Government of India - Ministry of Railways
Research, Designs & Standards Organization,
LUCKNOW - 226011

No. EL/3.1.35/4

MODIFICATION SHEET NO.RDSO/2019/EL/MS/0477 (REV. '0'), Dated 18.06.2019.

Operations of WAP-5/ WAP-7 in push pull

Fig. 2: Schematic of Jumper

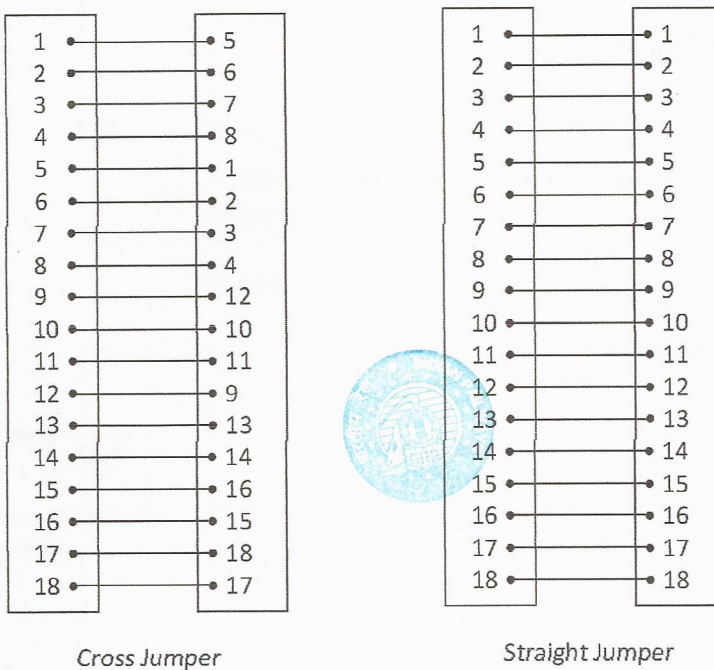
- d Revised construction details of the Jumper between Loco and the first/last coach/power car need to be as follows:
- e Modification required in compressor control circuit
- Remove the loop between XF77S:01 23 and XF77S:01 24 provided as per RDSO Modification Sheet no. RDSO/2013/EL/MS/0427 (Rev. '0') dated 23.10.2013.
 - Remove the wire no. 3038 from Q2 terminal of 172.3 (pressure switch main compressor 36) and connect it to Q1 terminal of the 172.3 i.e. connect to the wire no. 3101.
 - Put the switch ECPSW in OFF position as provided by VCU redundancy modification suggested by CLW if provided.

MODIFICATION IN A-PANEL DRIVER DESK.

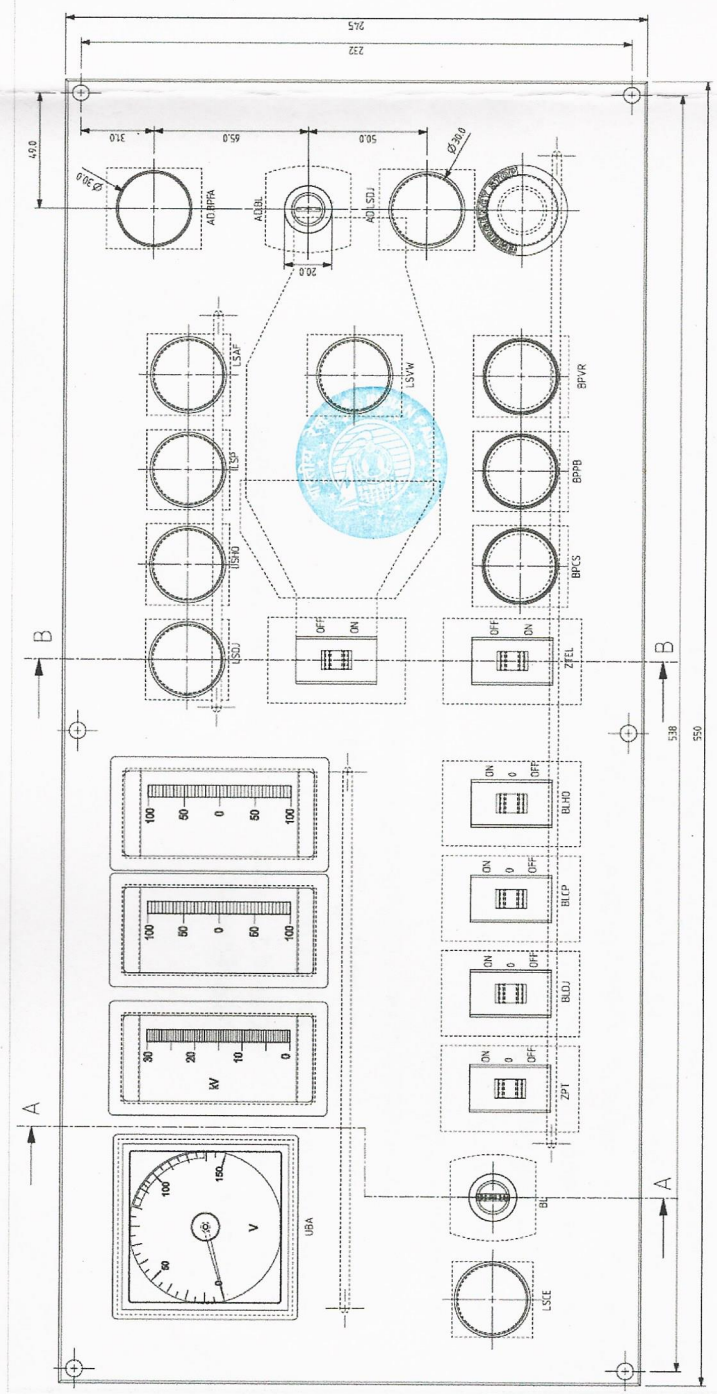
(A) Modification in A-Panel Driver Desk: Details given in annexure-II

- a. Additional BL key switch (125) socket, additional BPFA (163.1) and additional indication lamp LSDJ (137.3) to be fitted on both the CAB driver desks in both locomotives.
- b. Existing BL connection 9 wire no 2067 to Add BL connection 9. Wire no. 2067 also available in Cab-1 WAGO connector XF13A:01 15 and Cab-2 WAGO connector XF86A:01 15. Wire loop will be connected from these WAGO to Add BL key connection 9 in respective Cab.
- c. The following cable connection shall be done for duplication of BL Key, BLDJ & BPFA.
 - i. Cable Harness:
